VALIDATION OF THE REVISED MONITORING PLAN

Gimcheon PV Power Plant Site 2 CDM Project

UNFCCC Ref. No. 2684

REPORT No. 2011-05

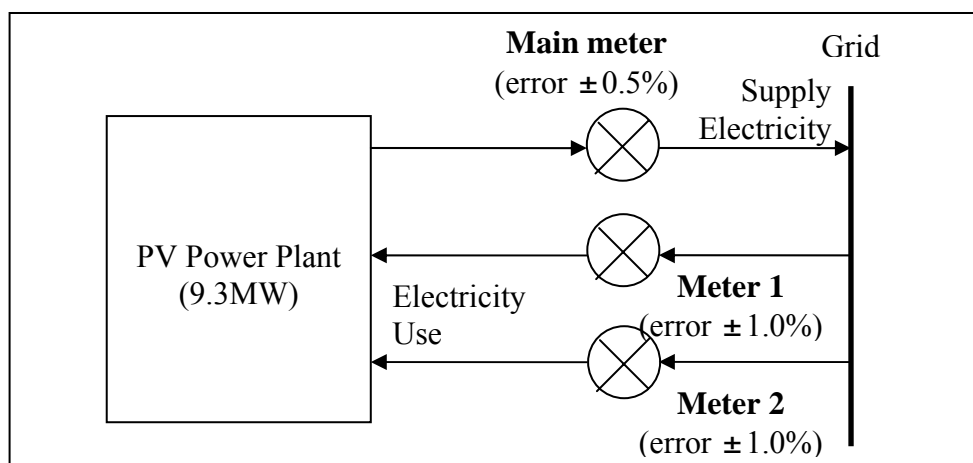
Meter to measure electricity from the Grid is added as requested by Korea Electric Power Corporation (KEPCO)

EGy, net electricity generation by the project activity is only parameter to be monitored to calculate emission reduction by this project activity during the crediting period. To monitor EGy, measurement of electricity supplied to the Grid and electricity supplied from the Grid need to monitor. According to the registered PDD Version 5 (5 June 2009), there are total 2 meters: 1 meter to measure electricity supplied to the Grid and 1 meter to measure electricity from the Grid respectively. However, as per 'Electricity Enterprises Act', additional meter to measure electricity from the Grid is required to be installed and it measures general electricity consumption for street lights, security system within the project boundary which is not directly

related to power generation by this project activity. And, at the same time, existed meter for measuring electricity supplied from the Grid was replaced to new meter as per KEPCO request.

In conclusion, there are total 3 meters to monitor EGy: 1 meter to measure electricity supplied to the Grid (main meter) and 2 meters to measure electricity delivered from the Grid to the Project (One for the industrial electricity use and other one is to measure general electricity use).

The validation team checked notice issued by KEPCO to trail changes in number of meters at the project site. The registrar of newly added meters are also checked to confirm accuracy level of meter ($\pm 1.0\%$), serial number and date of installation of the meter (23 September 2009) as well as physical site visit.

And it is also confirmed that PP have well described monitoring plan for the meter added including calibration frequency in the revised monitoring plan and the revised monitoring plan have implemented properly.
